Swiss Federal Office of Energy SFOE
Section TS

Final Report dated March 25, 2024

Peer Review of the Swiss Dam Safety Guideline, Part C3, version 2021 “Earthquake Safety”

Phase 1 – Chairman report

Fig 7. Soil coefficient for classes A and EC-8 in Felicetta et al. (2018).

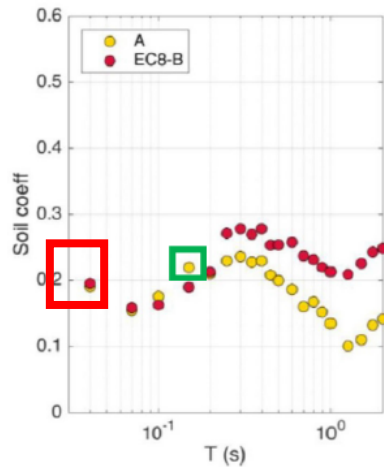
A $C_A=1.66$ was estimated using the plot shown below where C_A (soil coefficient) to convert site class A ($V_{s30}>800$ m/sec) and soil class EC8-B (360 m/sec $<V_{s30}<800$ m/sec) into "reference rock", A_{ref} , for Italy, resulting in a value of $10^{(0.22)}$. We note that the definition of "reference rock" in Felicetta et al. (2018) was defined using six proxies based on geological, topographical and geophysical data to identify reference rock sites (A_{ref}) and, therefore, it does not correspond exactly to the Swiss reference rock (based only on $V_{s30}=1100$ m/sec). The objective of Felicetta et al. (2018) study was to introduce a new site soil category and to re-calibrate the ITA10 prediction equations for this new soil class and not to determine an amplification factor between A_{ref} and soil class A or B, although it was presented (see Figure 7 here below). In Figure 7, at T=0.15 sec, the amplification factor proposed for soil class A (factor to convert reference rock into soil class rock) is higher than the amplification factor proposed for soil class B, which seems unusual.

This report justifies the adoption of $C_A=1.6$ using four M-R pairs and Italian data which raises the question whether such data are appropriate for Switzerland.

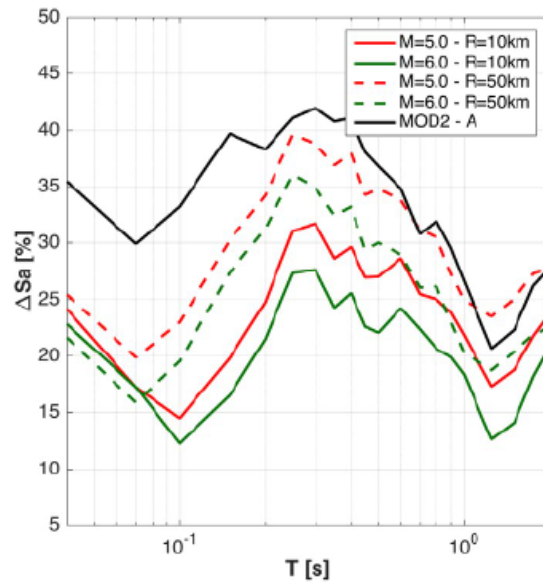
- The adjustment factor obtained for $M=6.0$ is lower than the value obtained using $M=5.0$ (see Figure 6 of Felicetta et al., 2018 here below). The amount of reduction is directly related to an amplification factor). This strain-dependent pattern is also shown in ASCE7 and the French seismic code for large dams.
- The adjustment factor for PGA (red rectangle in above figure) is significantly lower than the amplification value for $T=0.15s$ (green rectangle).

Figure A2: Relationship between response spectra for soil class A and UHS on the SED reference soil [SED 2017b].

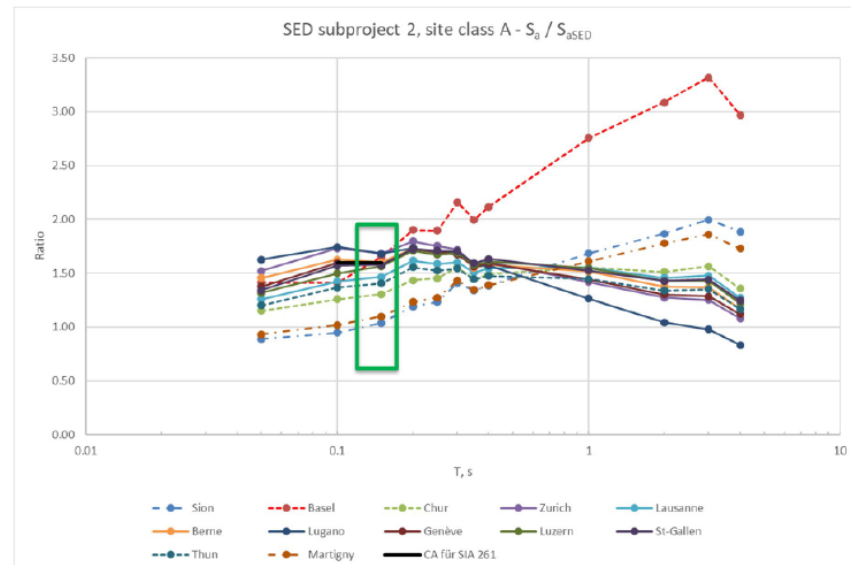
The figure that seems to justify the $CA=1.64$ value is presented here below (Figure A2 in Duverney et al., 2019):

We were unable to find Figure A2 in the report by Danciu and Fah (2017) *Adjustment of the 2015 updates of the Swiss Hazard Model to different rock conditions (Vs-kappa adjustment)*. This is a key figure which probably provides the strongest argument for a C_A of 1.6. The adjustment factors derived in Danciu and Fah (2017) are close to 1.1 or 1.2. The report's Appendix the adjustment factors for 0.15 sec, the listed C_A factor 1.1158 (red rectangle). The adjustment factor for PGA is only 1.0525 (blue rectangle). It is unclear how the stated 1.64 was derived considering the available information. Additional details about that should be requested to SED.

- 6) The SED 2017 report appears to “predict” adjustment factors ranging from 1.1 to 1.2. However, Figure A2 in Duverney et al. (2019) shows higher values. Maybe other considerations were included (“median” to mean” conversion, for example?). This needs more clarification. This is a key issue. The Vs-Kappa adjustments performed by SED seems to lead to C_A factors ranging from 1.1 to 1.2.
